Section 4.55 application

MOD2019/0619

Golledge McLean Residence
19 Kooloora Avenue,
Freshwater, NSW 2099
Lot 16 Section 2 DP.7022

Location Plan, Site Analysis & Basix Commitments

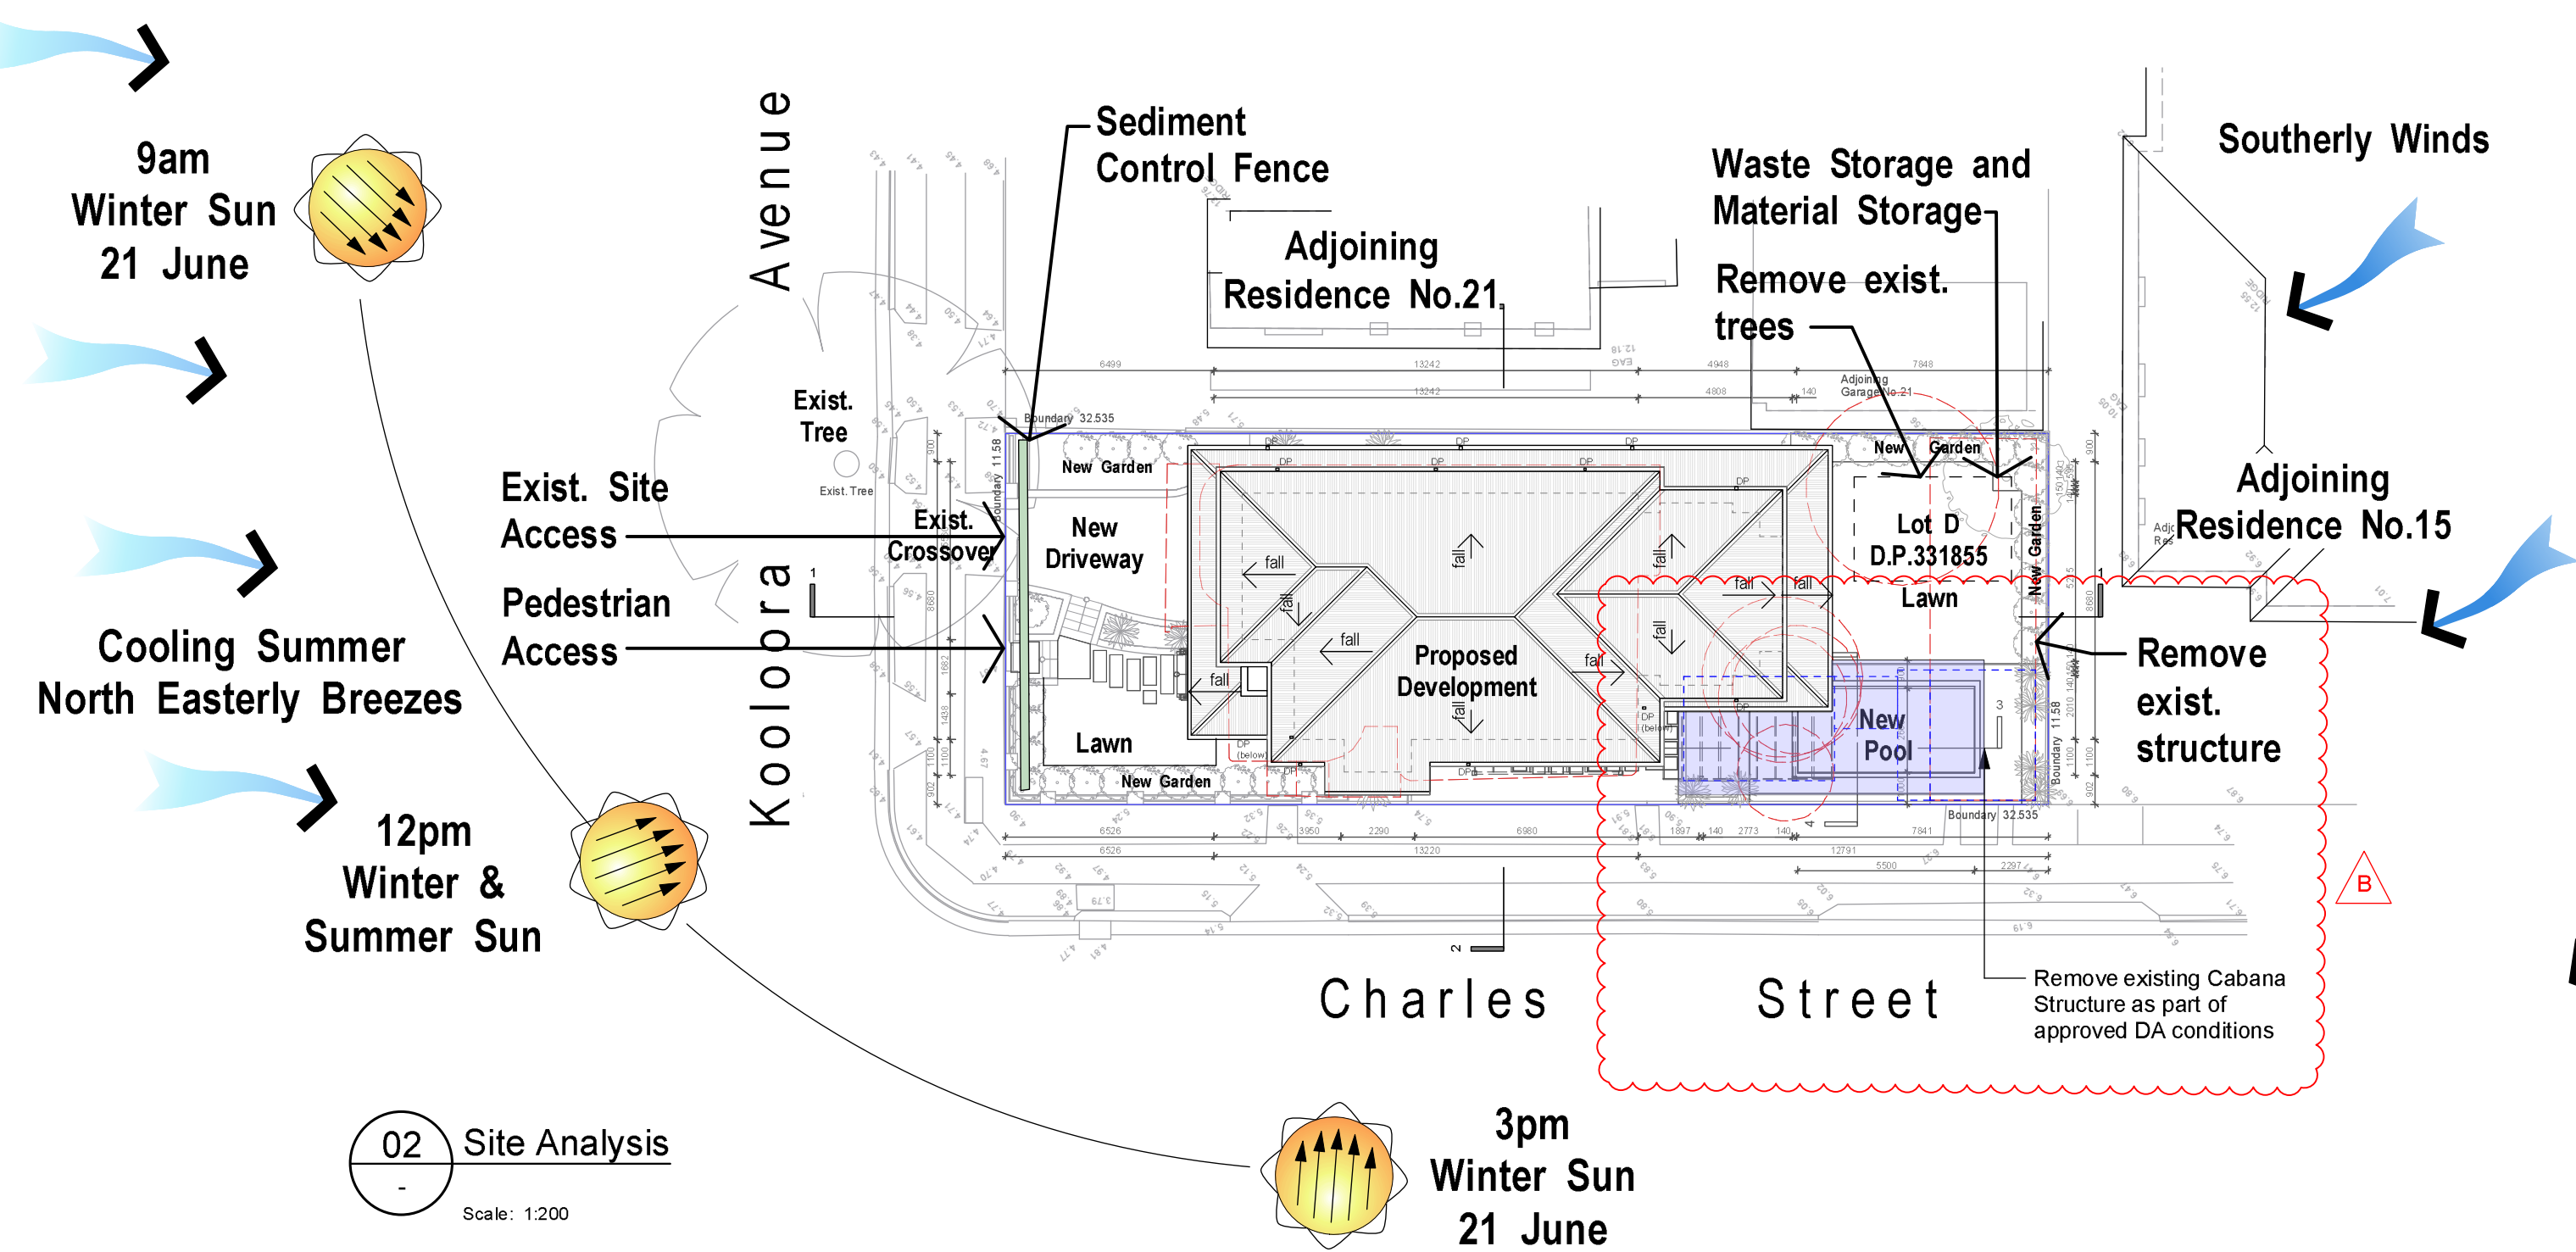
B	19/11/19	Section 4.55 Application for Pool and Pergola repositioned	KvB
A	19/7/19	DA Issue	KvB
rev	date	revision notes	by
Figured dimensions to be taken in preference to scaling. Contractor to verify all dimensions on job before commencing any work or making shop drawings			
Copyright remains the property of Playoust Churcher Architects. Reproduction of the whole or part of this document constitutes an infringement of copyright. The information, ideas and concepts contained in this document are confidential			
project	project#		19-774

19 Kooloora Avenue, Freshwater, NSW 2099 Lot 16 Section 2 DP.7022			
client			
Mr W. Golledge and Mrs L. McLean			
dwg			
Elevations			
printed	drawn	cid	scale@A1
20/11/19	KvB	JH	1:100

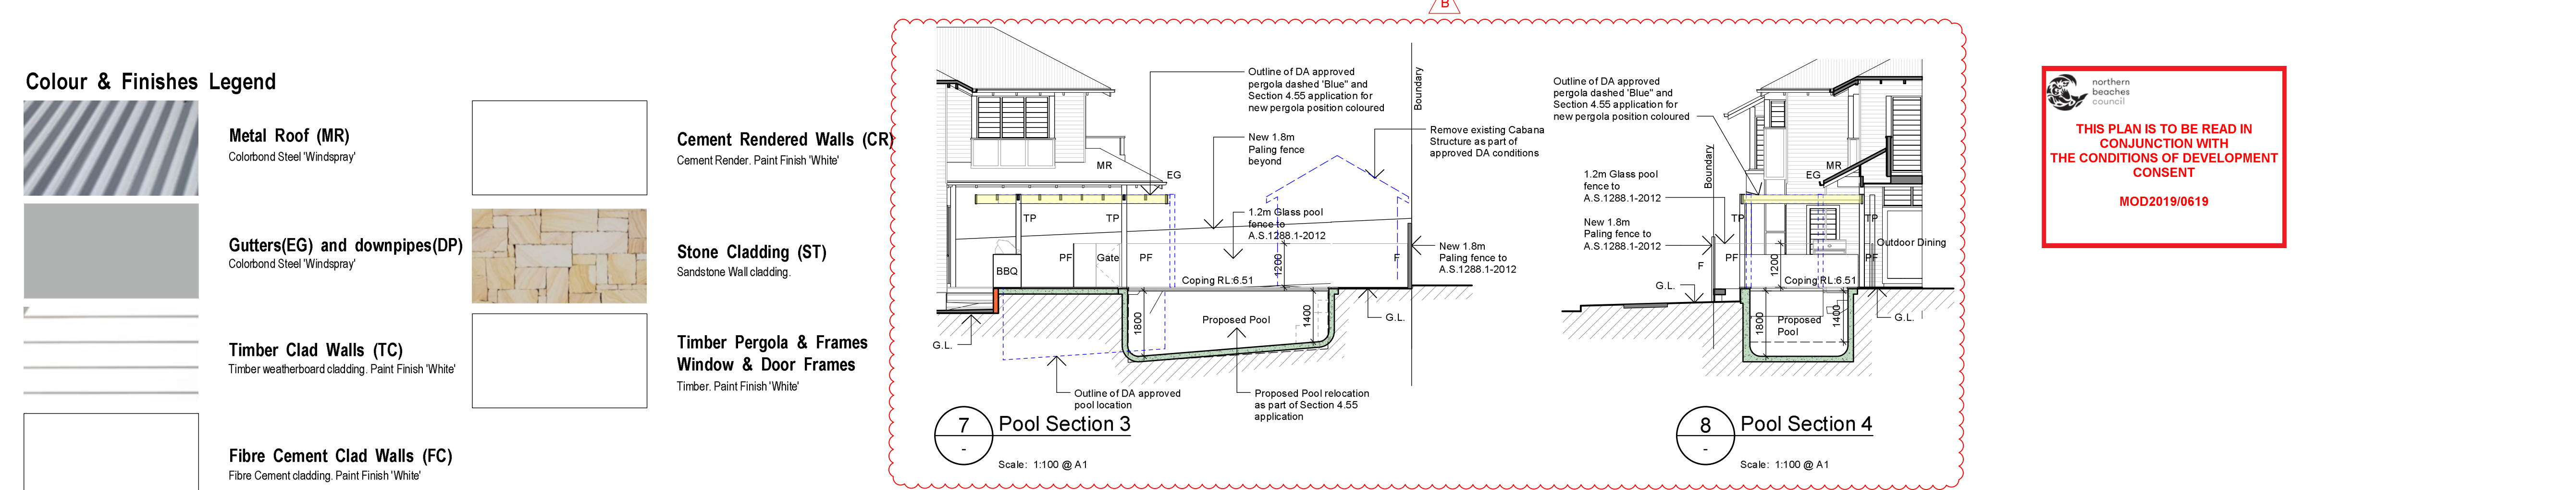
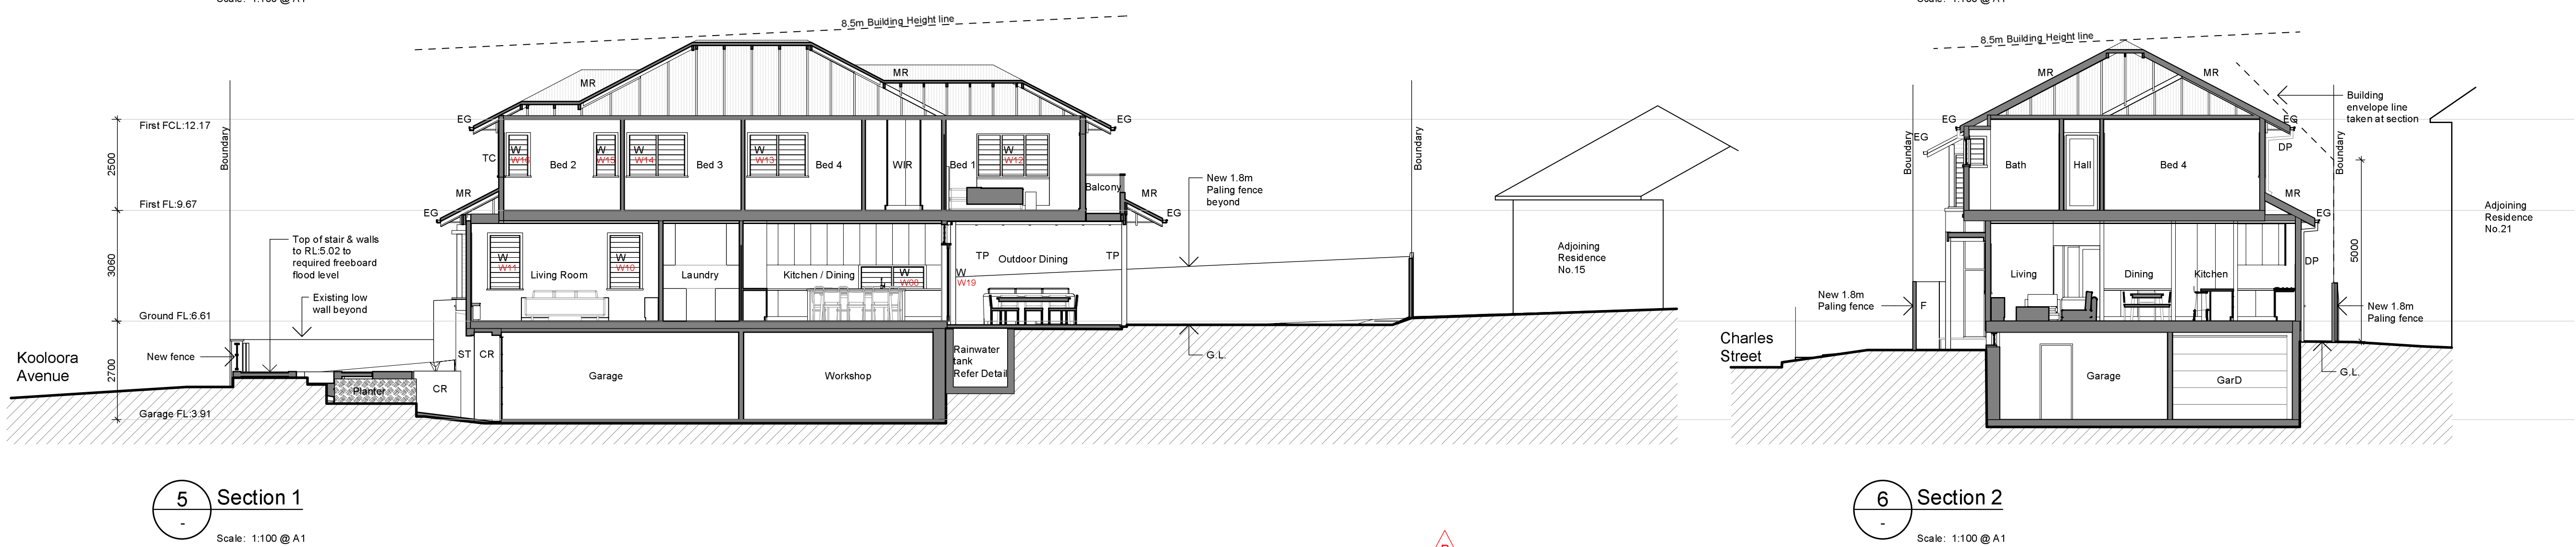
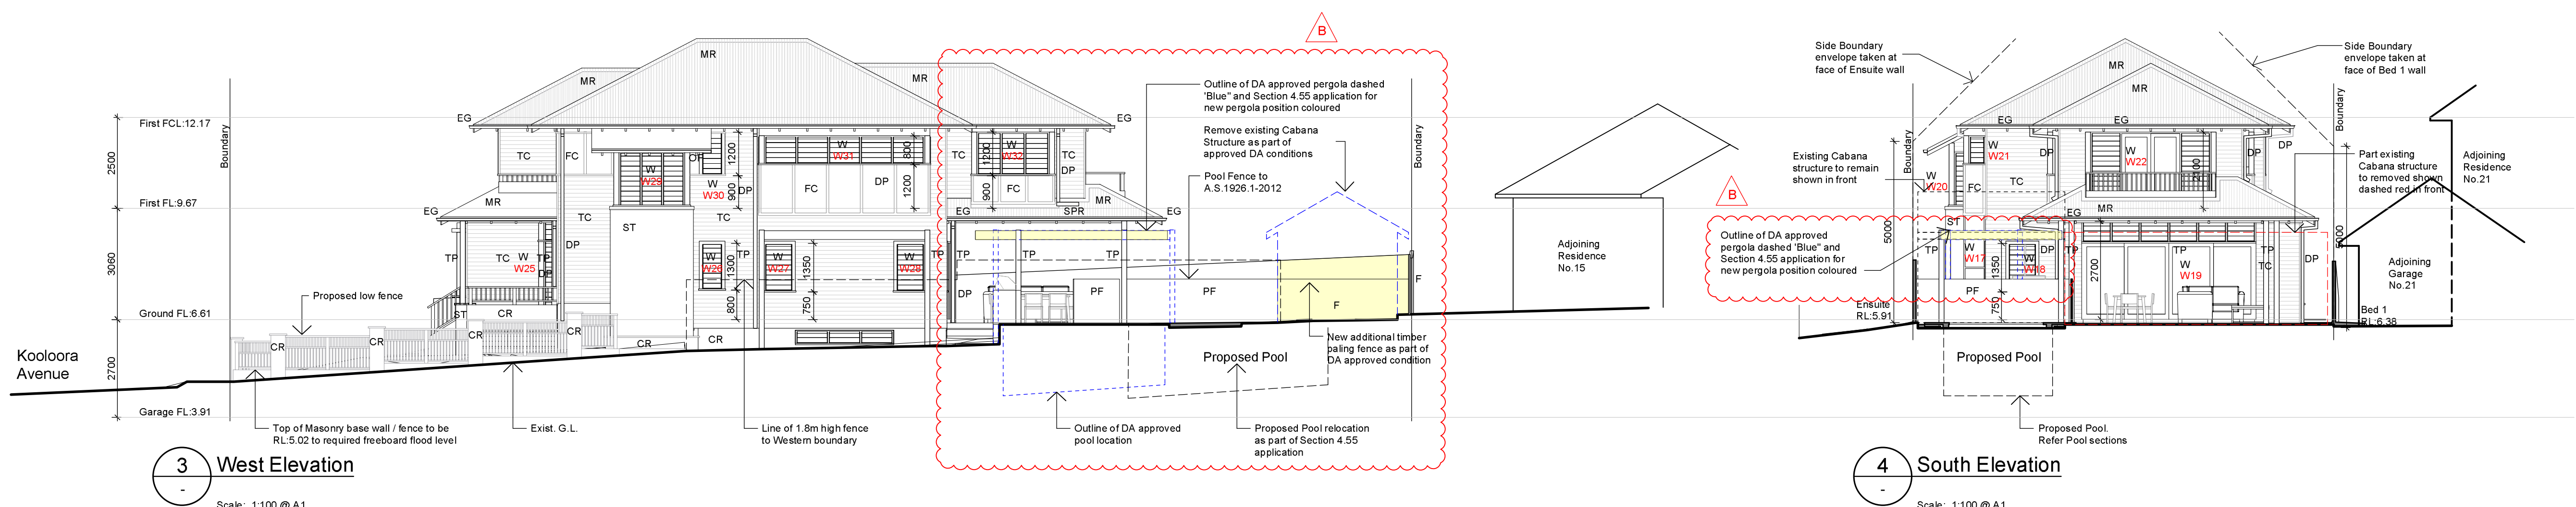
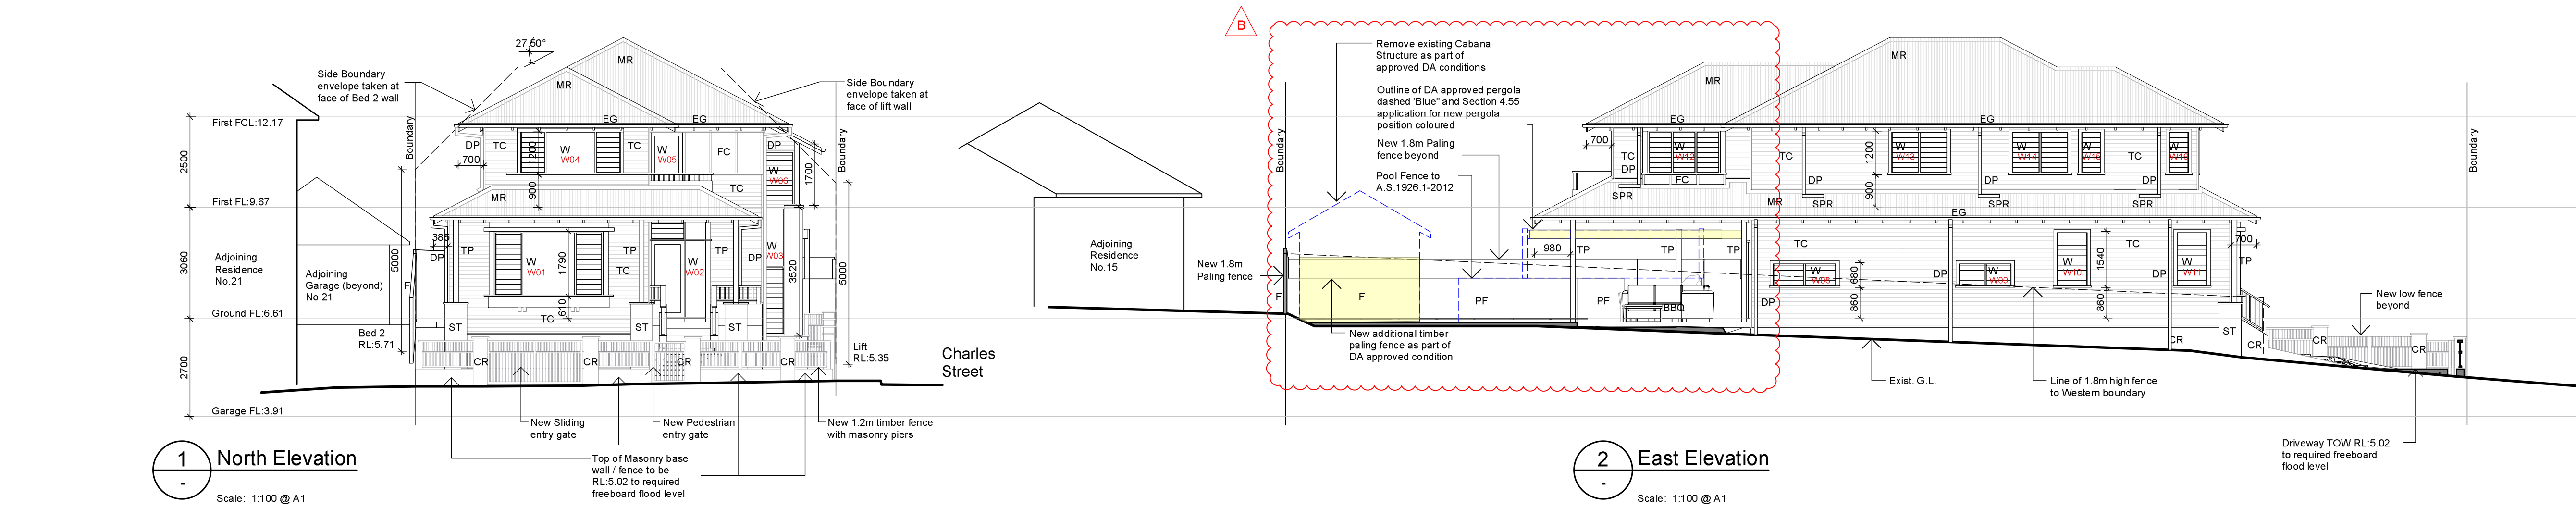
B	20/11/19	Section 4.55 Application for Pool and Pergola repositioned. Flood barrier and freeboard height notes added to front fence and gate.	KvB
A	19/7/19	DA Issue	KvB
rev	date	revision notes	by
